FINAL PLAT OF YMCA SOUTH ADDITION

Re: S/D 98-15 -- Final Plat of YMCA SOUTH ADDITION

Re: S/D 98-15 -- Final Plat of YMCA SOUTH ADDITION

CASE NUMBER: S/D 98-15 - YMCA SOUTH ADDITION

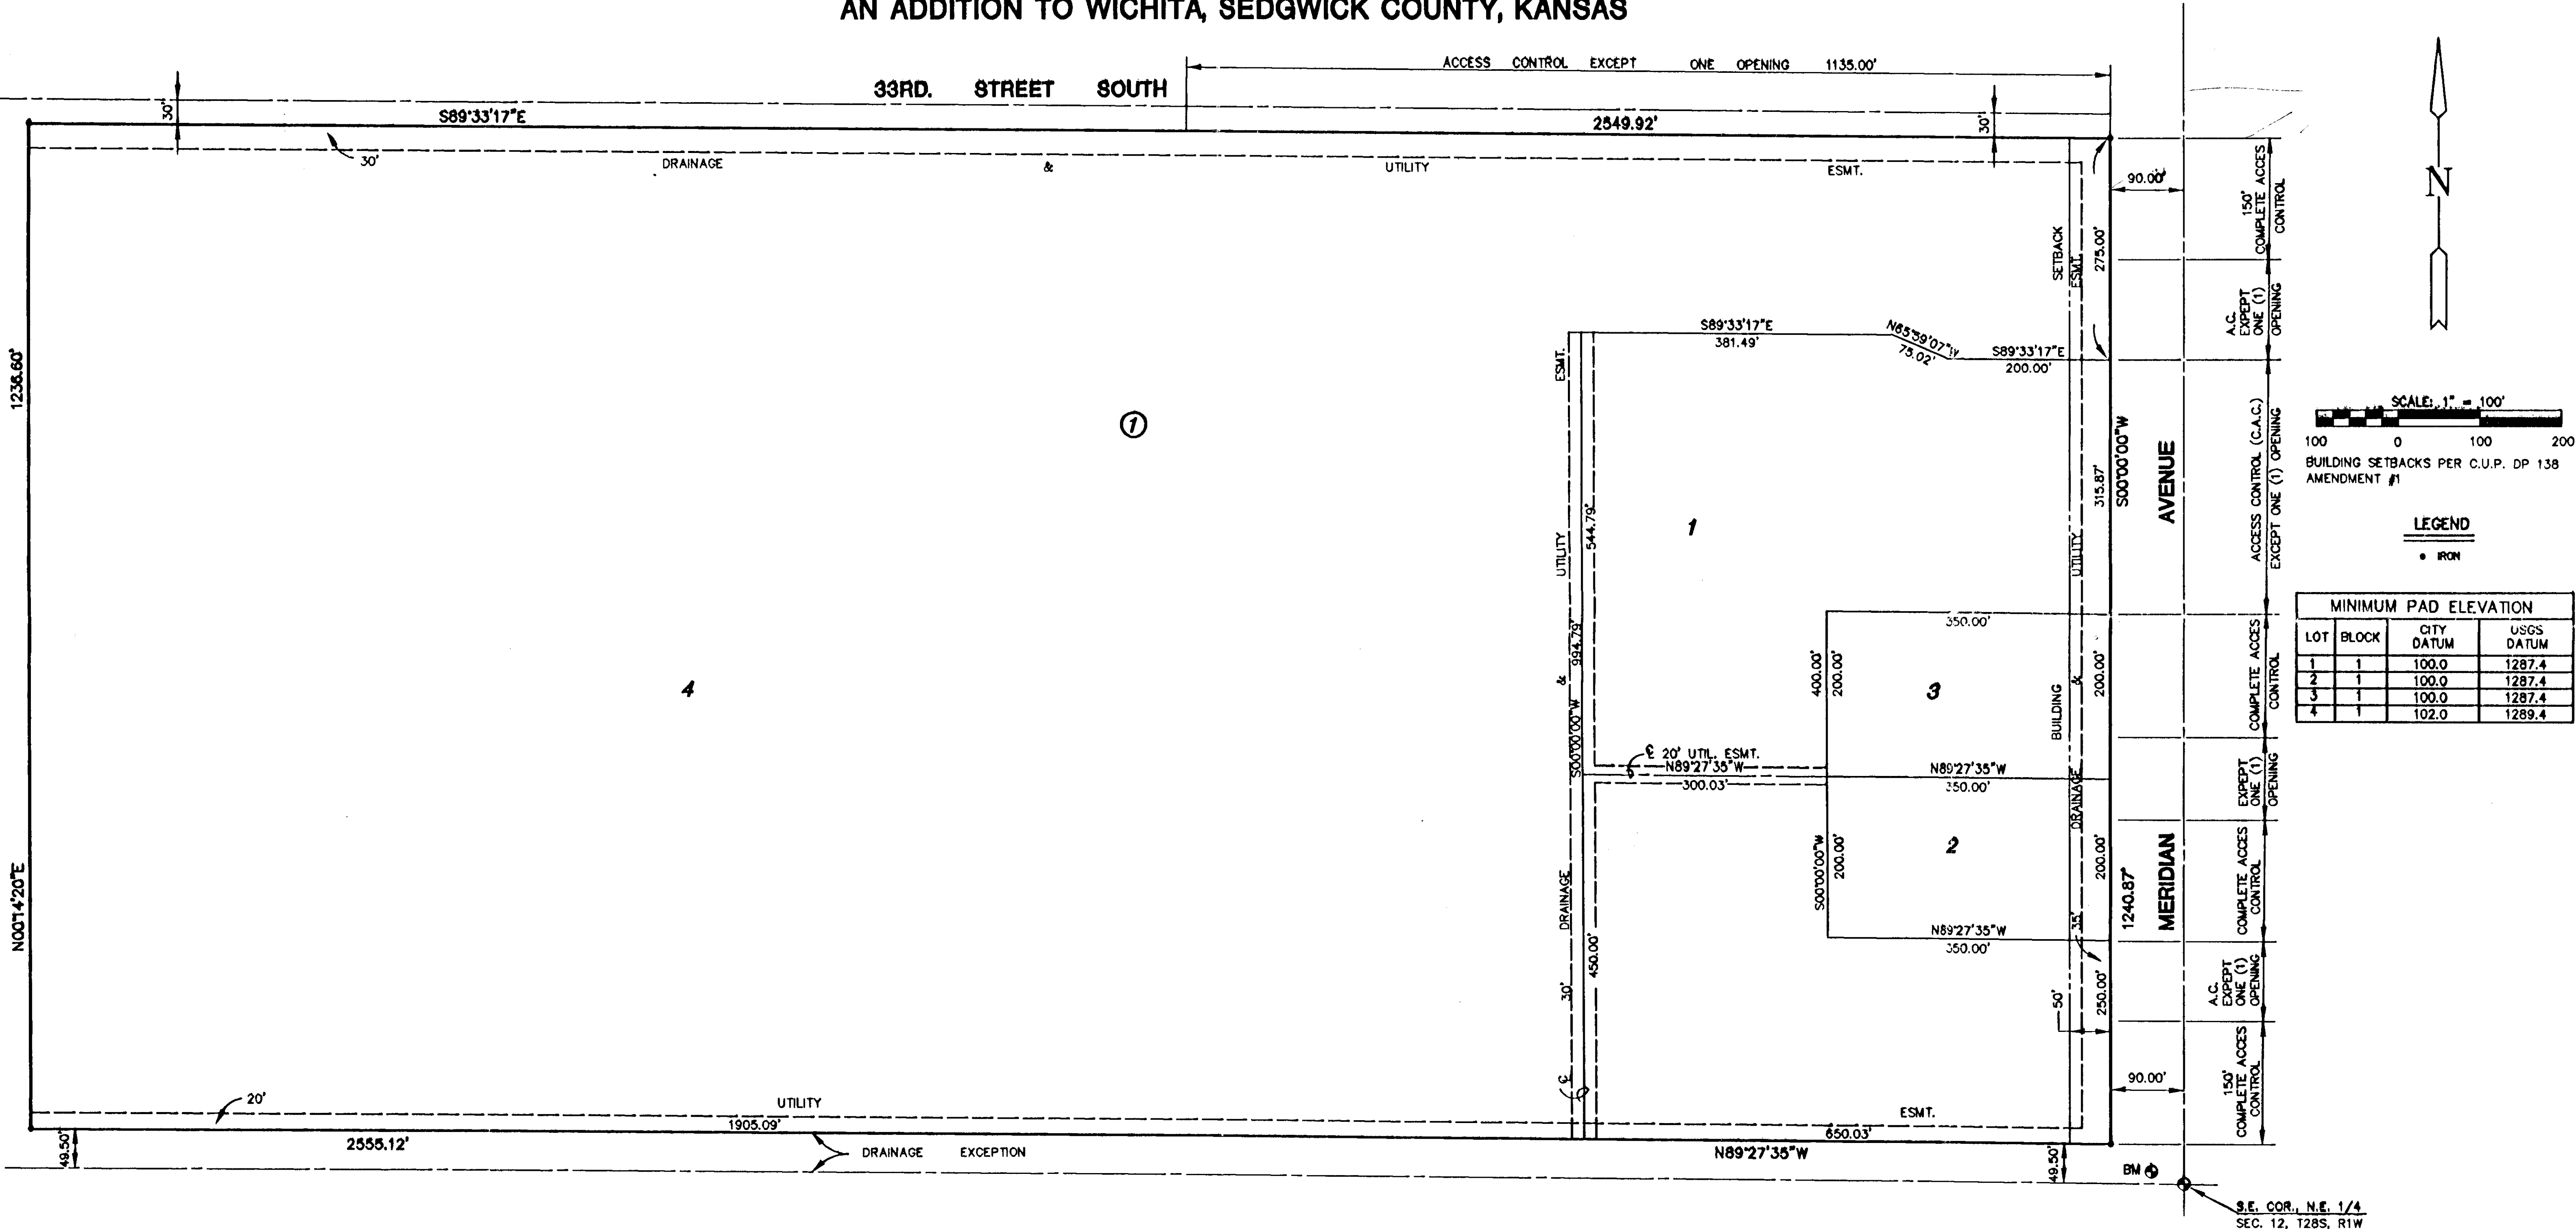
- D. The plat does not conform with the access controls approved for the CUP. The plat denotes five openings along Meridian; whereas the CUP restricted the site to four openings. The CUP also required a joint access between lots 1 and 2. The joint access easement will need to be established by separate instrument. Initial construction responsibilities and future maintenance of the driveway within the easement should also be addressed by the text of the instrument. Four openings, in conformance with the CUP, are required. Joint access between lots 2 and 3 will be needed - and an adjustment to the CUP will have to be made. Complete access control shall be required along the northern 150 feet of the northern lot (lot 4). Complete access control is required along the southern 150 feet of the southern lot (lot 1).

- E. ☒ On the final plat tracing, the platlor's text shall specifically note that the access controls are being dedicated to the City of Wichita.

- G. As required by the CUP, the applicant shall guarantee paving of the south half of 33rd Street South from Meridian to Gordon. Traffic Engineering needs to comment on the need for improvements to Meridian. A decel lane for the driveway to lot 4 is required. Decel lanes for other lots may be required when development plans are finalized by the applicant.

U. *City Fire requests that a gate be installed if a fence is constructed along the 33rd Street.*

☒ The final plat denotes four openings along Meridian and a joint access between lots 2 and 3 in accordance with the above requirements.
